Access Compliance Report

Public Rights-of-Way

Intersection ID: 42753	Main Street: WATTS_BLUFF_DR	Cross Street: ASHLEY_MEADOW_DR	Location: SE
ADA ID: 85CDBD754CCB	Ramp Type: PerpDiag	Initial Pass/Fail: Fail	Overall Compliance: No
Severity Score: 18.75			
Codes/Mitigation Info/Possible Solution		Field Measurements/Component Compliance

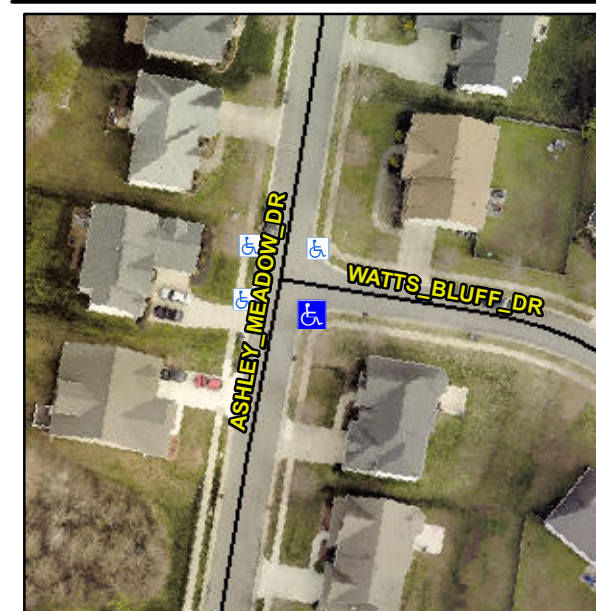
Not Found, R304.5.1, R304.5.3

Compliance	Description	Data	Compliance	Description	Data
N/A	Ramp Length (in)	48.5	Yes	Ramp Slope (%)	6.1
No	Ramp Width (in)	35.0	No	Ramp XSlope (%)	4.9
N/A	Flare Type LT	N/A	N/A	Flare Type RT	N/A
N/A	Flare Slope LT (%)	N/A	N/A	Flare Slope RT (%)	N/A
N/A	Flare Traversable LT?	N/A	N/A	Flare Traversable RT?	N/A
N/A	Landing Length (in)	N/A	N/A	DWS Provided?	N/A
N/A	Landing Width (in)	N/A	N/A	DWS Contrast?	N/A
N/A	Landing Slope (%)	N/A	N/A	DWS Length (in)	N/A
N/A	Landing X Slope (%)	N/A	N/A	DWS Full Width?	N/A
N/A	Landing Curb? (Y/N)	N/A	N/A	DWS Offset (in)	N/A
N/A	Shared Landing?	N/A			
N/A	Gutter Ponding?	N/A	N/A	Gutter Slope (%)	N/A
N/A	Gutter Lip Ht (in)	N/A	N/A	Gutter X Slope (%)	N/A
N/A	Painted X Walk1?	No	N/A	Painted X Walk2?	No
	X Walk 1 Direction	To E		X Walk 2 Direction	To W
N/A	X Walk 1 Width (in)	N/A	N/A	X Walk 2 Width (in)	N/A
	X Walk 1 Slope (%)	1.5		X Walk 2 Slope (%)	0.2
	X Walk 1 X Slope (%)	3.4		X Walk 2 X Slope (%)	2.6

Remove & Replace Curb Ramp With Two New Directional Ramps or Equivalent.
